From: Y.V. Nguyen, G.V. Abi-Ghanem, D. Heaps, K. Shimko/EWA Inc.

Subject: Review of "Assessment of Conducting a Large Shaft Demonstration Test Utilizing Geodril 32, Morrison-Knudsen Company, Inc., September 20, 1984."

Date: July 15, 1985

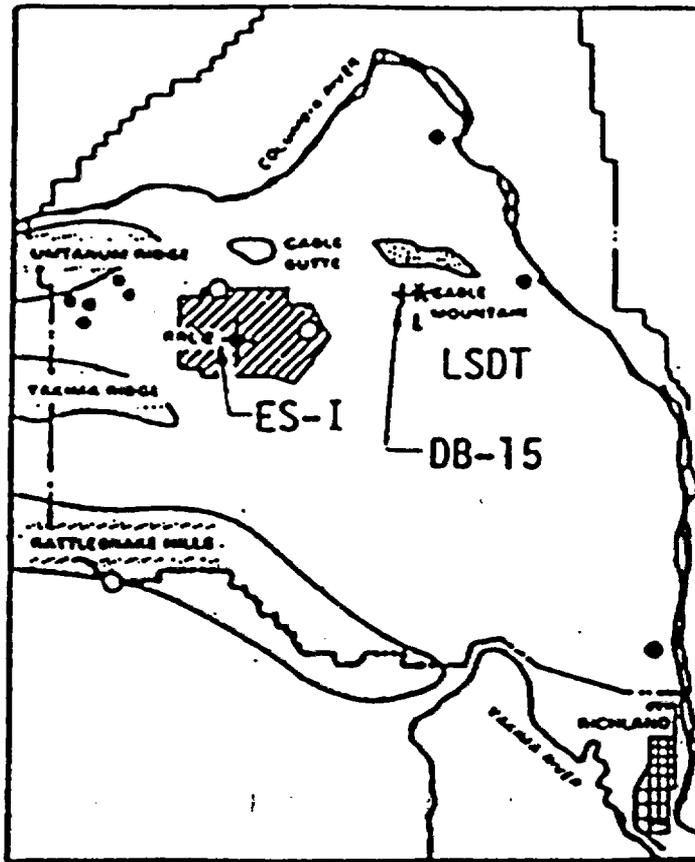
The Rockwell-recommended location of the LSDT is approximately one mile away from the borehole DB-15 (see Figure 1). Considering the distance between the LSDT and the Reference Repository Location (RRL), confidence level and utility of the geologic data generated by the LSDT may not be extrapolated to the full scale repository shafts in the RRL. Furthermore, well logs from RRL-2, a drill hole located approximately nine miles away from the LSDT Site, show poorly cemented or uncemented gravels and clays to a depth of 640 feet; below this depth, a repetitious sequence of moderately hard to extremely hard basalt flows and interlayered sedimentary horizons can be found (Morrison-Knudsen, 1983). Because of this fact and the depth planned in the LSDT, it is not certain if the LSDT hole can be used to check the effectiveness of available excavation technology in basalt flows, and to objectively extrapolate geologic hazards encountered at the LSDT site at depths greater than 500 ft.
